ORANGE COUNTY WATER DISTRICT
18700 Ward Street
Fountain Valley, California 92708

ADDENDUM NO. 4
TO
CONTRACT DOCUMENTS
FOR
CITY OF SANTA ANA
PFAS TREATEMENT AT JOHN GARTHE RESERVOIR
CONTRACT NO. SA-2025-1
11/5/2025

B D3101 HYDRO-GENERATOR SECTION
SCALE: 1/4"=1'-0"

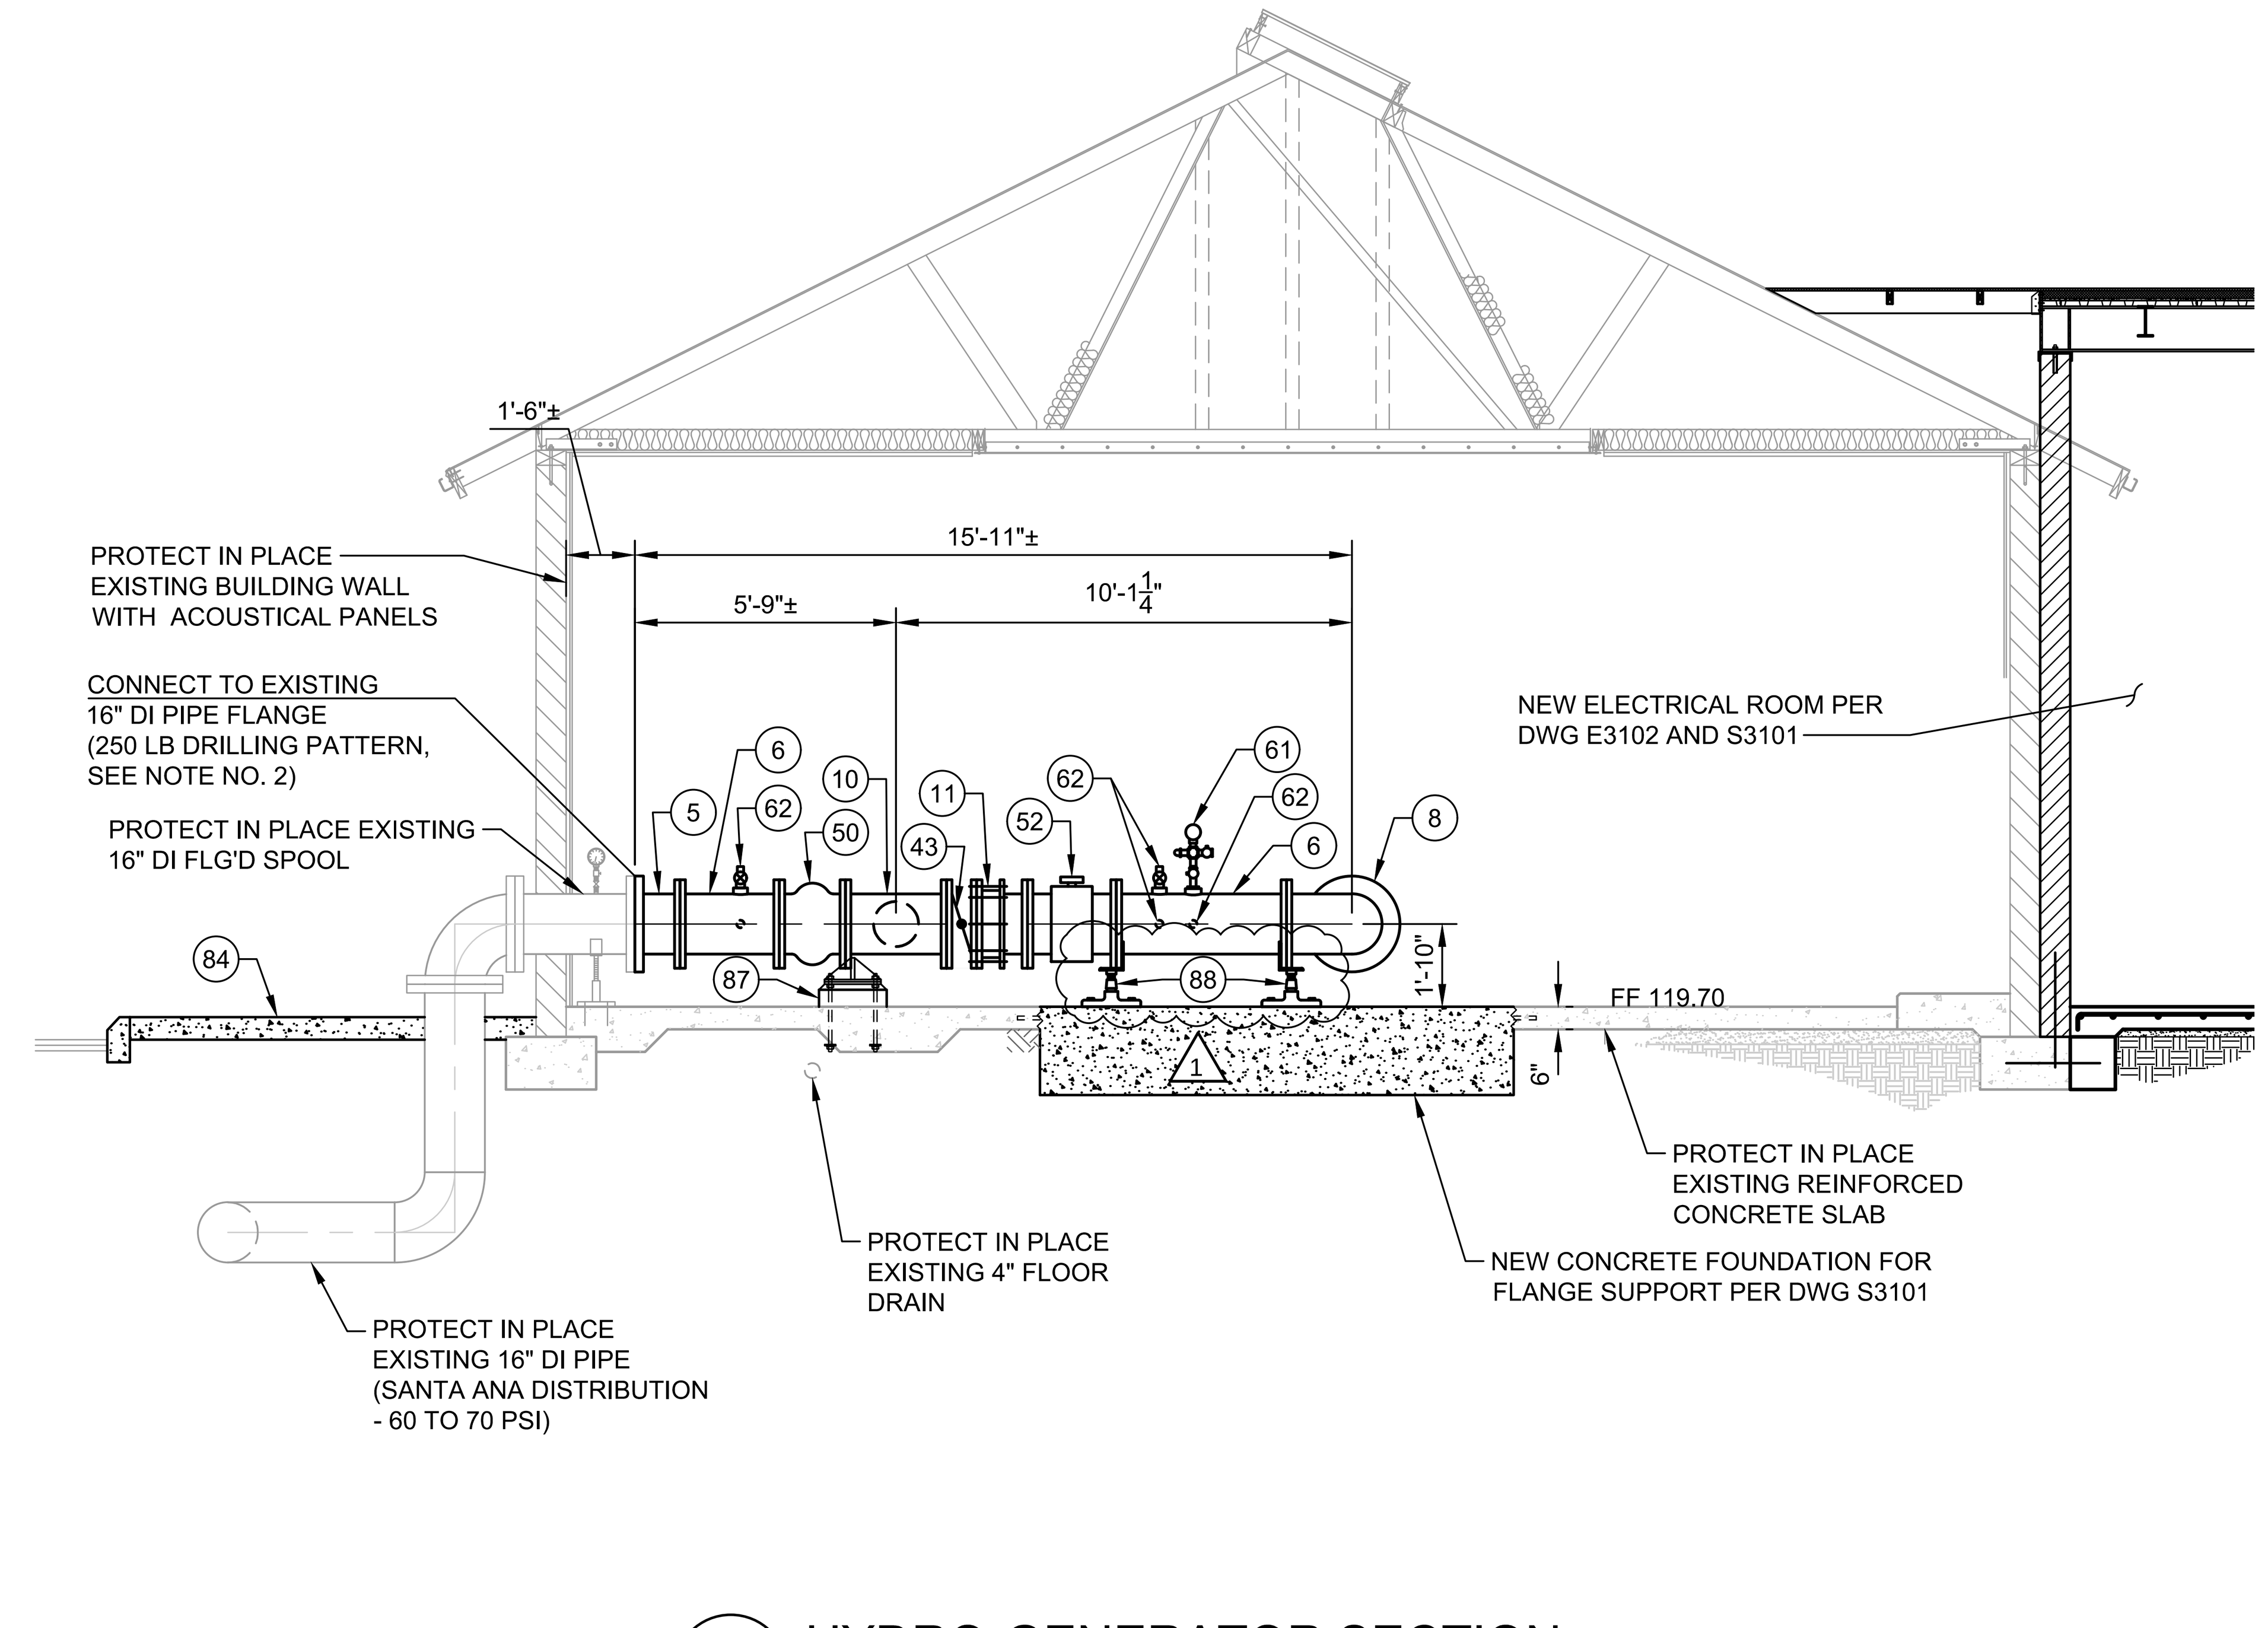
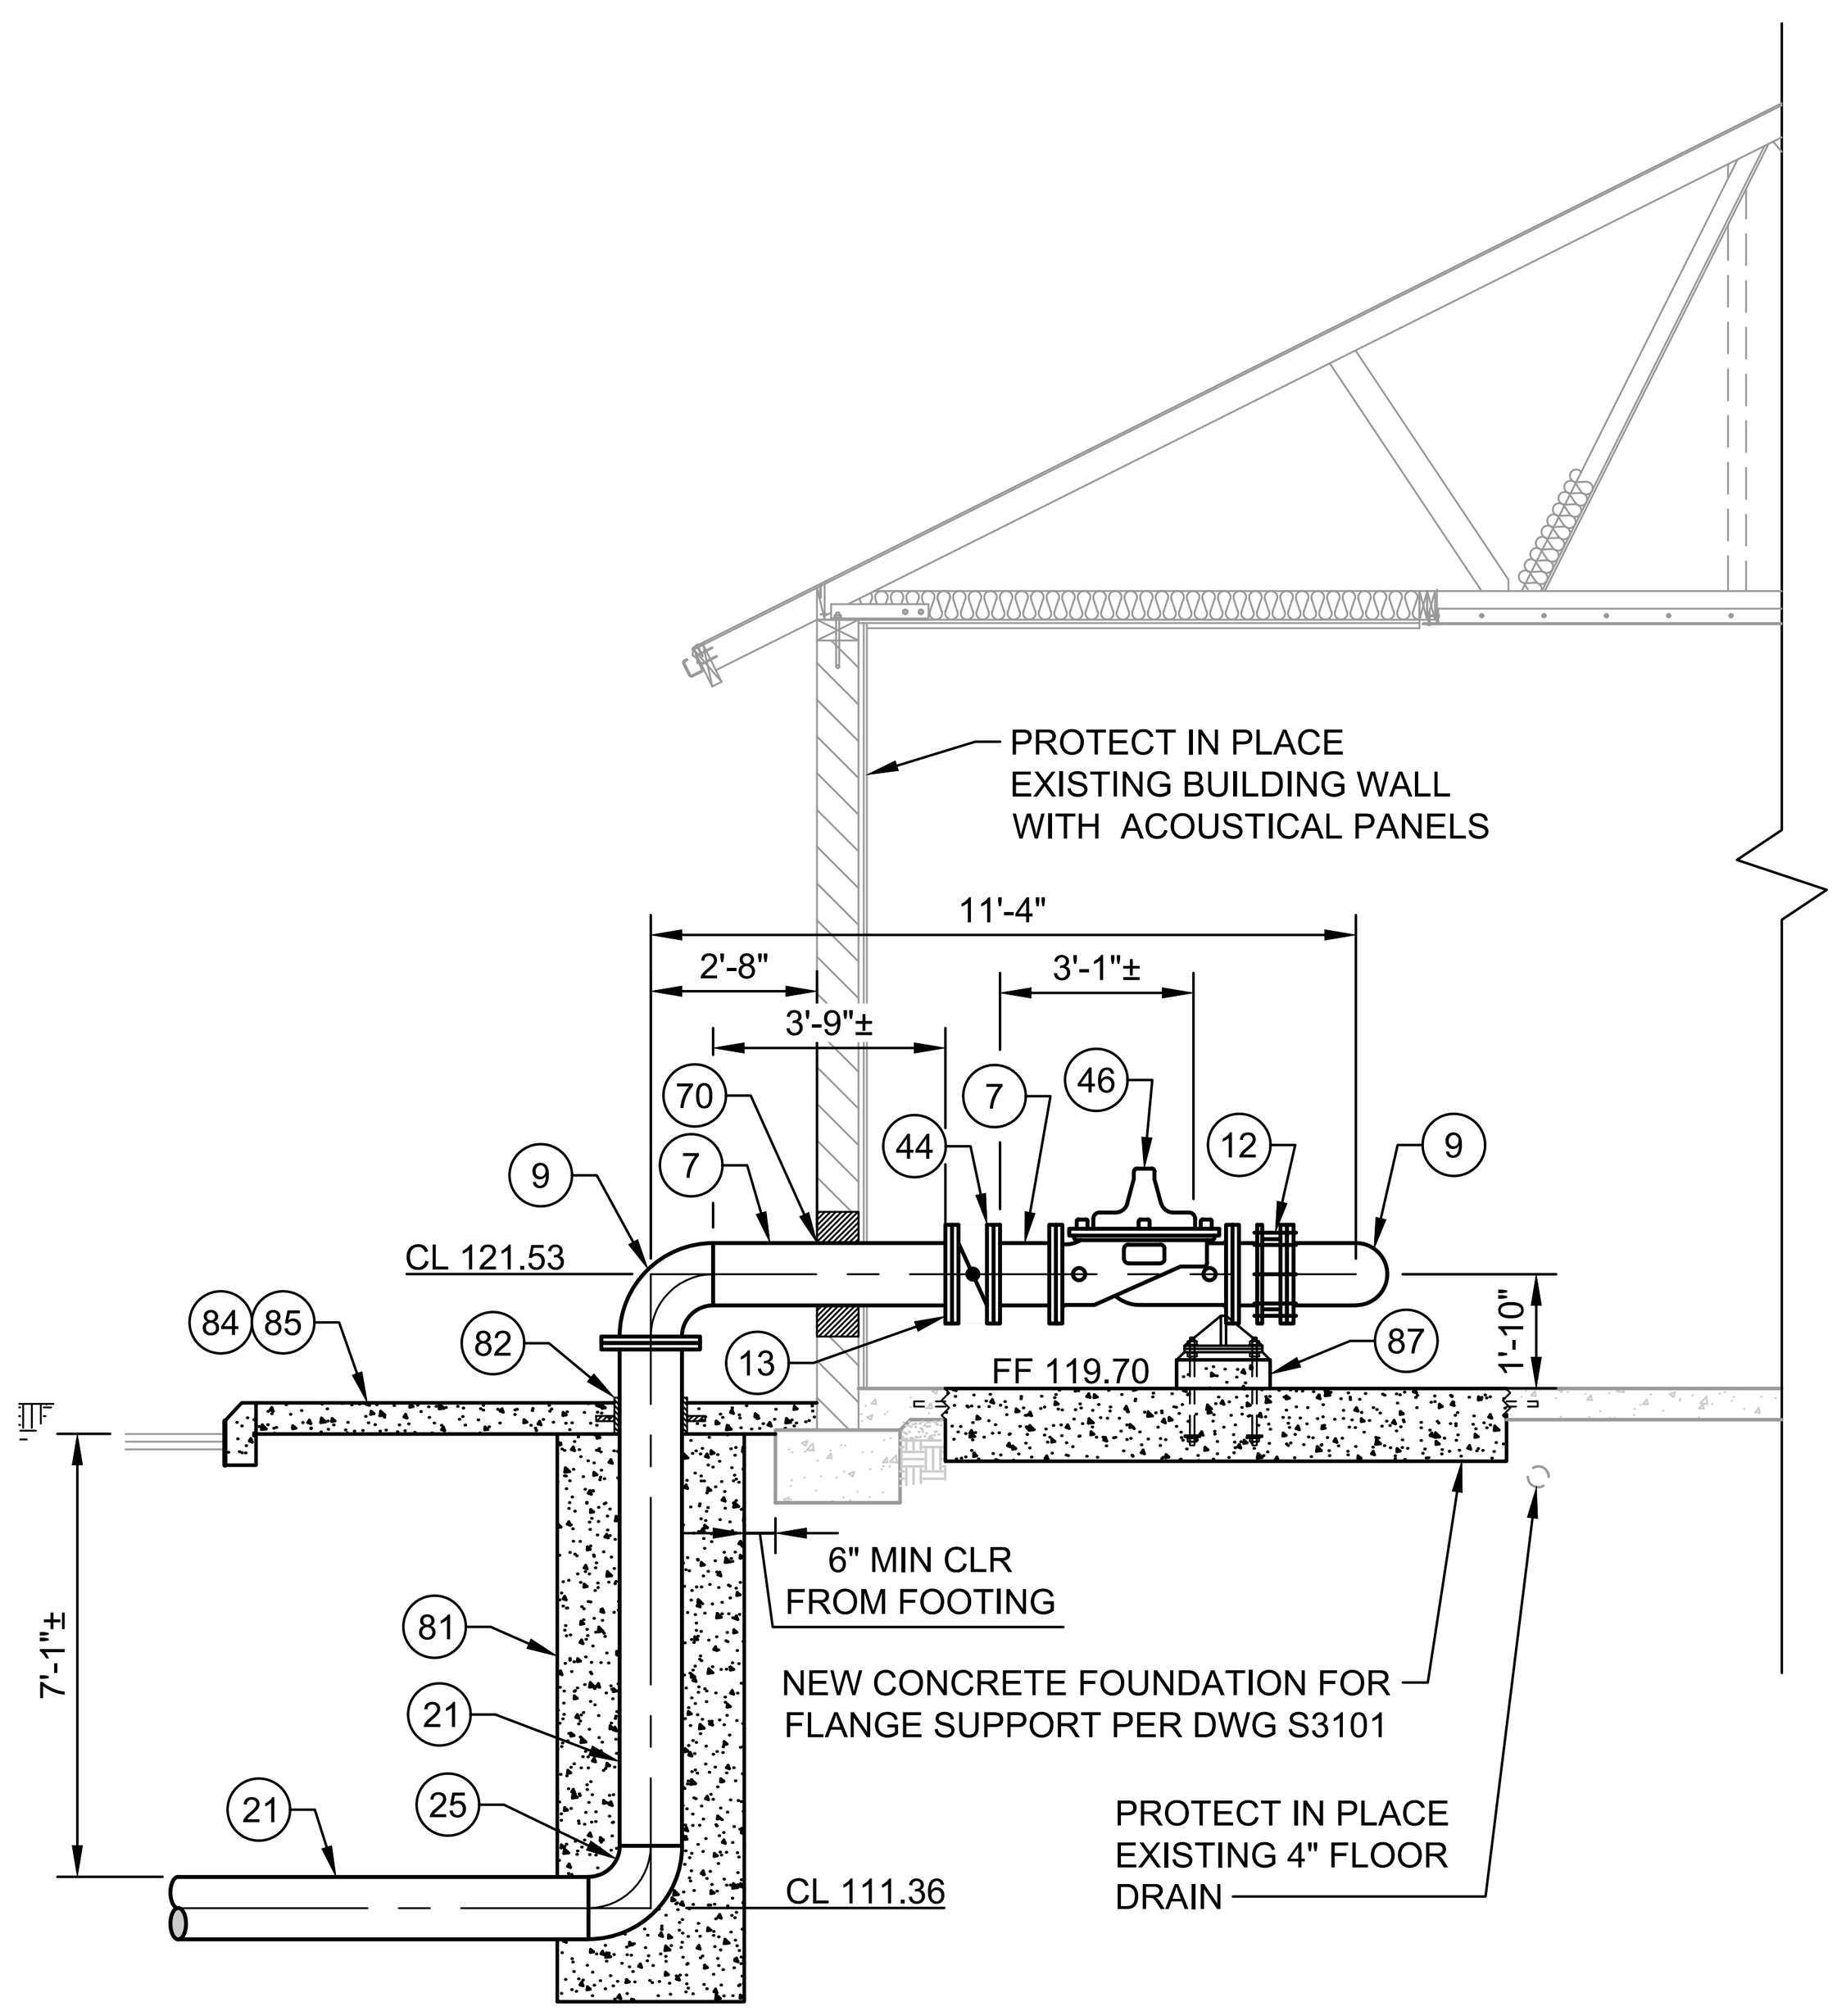
32	11. Please clarify what is intended to be entered into Bid Item #10 – Above Grade Pipe, as the other bid items in the IX area, OSHG building, Well building, Sand Filter, etc also state that they are to include the pipe.	Bid Item #10 is for all above grade piping that is not included in another specific bid item.
33	Drawing D0501 – Pre-Lube Assembly Backflow Preventer: Detail 8 on Drawing D0501 shows a backflow preventer in the pre-lube assembly. Since a backflow preventer already exists on the copper supply line, please confirm whether the additional backflow preventer is required.	Backflow preventer shown in detail is required - bid per plan.
34	• Drawing D0301 / D3302 – Coupling Type Clarification: Construction Note 68 on Drawing D0301 specifies a flexible coupling, while Construction Note 66 on Drawing D3302, Section D, indicates a grooved coupling at the same location. Please confirm which coupling type is correct.	Plan sheet D3101 has been revised to reflect Construction Note 66.

35	• Drawing D3101 – Port at 2" Air/Vac Assembly: On the Well 39 discharge piping shown in Drawing D3101, there is a port near the 2-inch air/vac assembly that is not labeled. Please confirm if this is intended to be a 1-inch flow meter test port.	This tap is a 2" spare pipe tap. Plans have been revised to show construction note 62.
36	Drawing D3101 / D3302 – Hydro Generator Pipeline Supports: Drawing D3101 shows three pipe supports on the 16-inch hydro generator pipeline, while Drawing D3302, Section B, shows only two supports. Please confirm the correct number and spacing of supports.	D3101 is correct - D3302 has been revised to reflect the three pipe supports.
37	Pipe Schedule: The bid documents (Construction Drawing, Specifications and Pipe Schedule) call for Schedule 80 PVC for the double containment carrier pipe, however, the construction notes calls for CPVC. Please clarify.	Construction notes will be updated for the sodium hypochlorite to call out PVC.
